Access Compliance Report

Public Rights-of-Way

Intersection ID: 22834	Main Street: PEPPERDINE_DR	Cross Street: WHITNEY_HILL_RD	Location: NW
ADA ID: F86D597ADBA3	Ramp Type: PerpDiag	Initial Pass/Fail: Fail	Overall Compliance: No
		Severity Score: 25

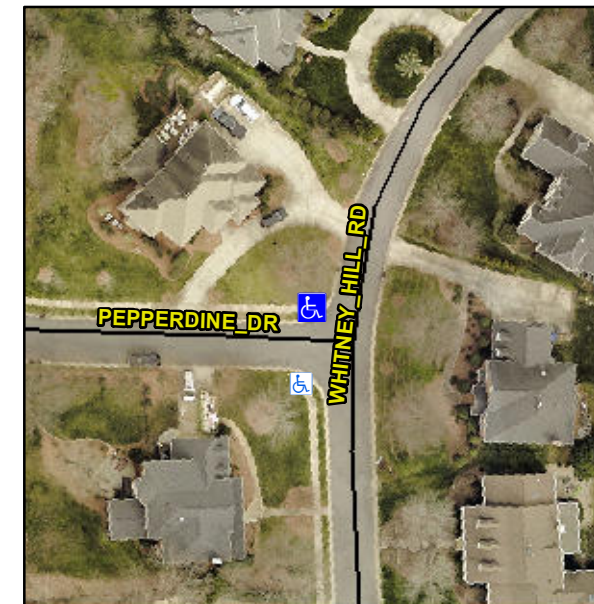
Not Found, R304.5.3

Compliance	Description	Data	Compliance	Description	Data
N/A	Ramp Length (in)	96.0	Yes	Ramp Slope (%)	5.2
Yes	Ramp Width (in)	48.0	No	Ramp XSlope (%)	11.2
N/A	Flare Type LT	N/A	N/A	Flare Type RT	N/A
N/A	Flare Slope LT (%)	N/A	N/A	Flare Slope RT (%)	N/A
N/A	Flare Traversable LT?	N/A	N/A	Flare Traversable RT?	N/A
N/A	Landing Length (in)	N/A	N/A	DWS Provided?	N/A
N/A	Landing Width (in)	N/A	N/A	DWS Contrast?	N/A
N/A	Landing Slope (%)	N/A	N/A	DWS Length (in)	N/A
N/A	Landing X Slope (%)	N/A	N/A	DWS Full Width?	N/A
N/A	Landing Curb? (Y/N)	N/A	N/A	DWS Offset (in)	N/A
N/A	Shared Landing?	N/A			
N/A	Gutter Ponding?	N/A	N/A	Gutter Slope (%)	N/A
N/A	Gutter Lip Ht (in)	N/A	N/A	Gutter X Slope (%)	N/A
N/A	Painted X Walk1?	No	N/A	Painted X Walk2?	No
	X Walk 1 Direction	To SE		X Walk 2 Direction	To E
N/A	X Walk 1 Width (in)	N/A	N/A	X Walk 2 Width (in)	N/A
	X Walk 1 Slope (%)	6.8		X Walk 2 Slope (%)	4.7
	X Walk 1 X Slope (%)	6.2		X Walk 2 X Slope (%)	4.6

Remove & Replace Curb Ramp With Two New Directional Ramps or Equivalent.
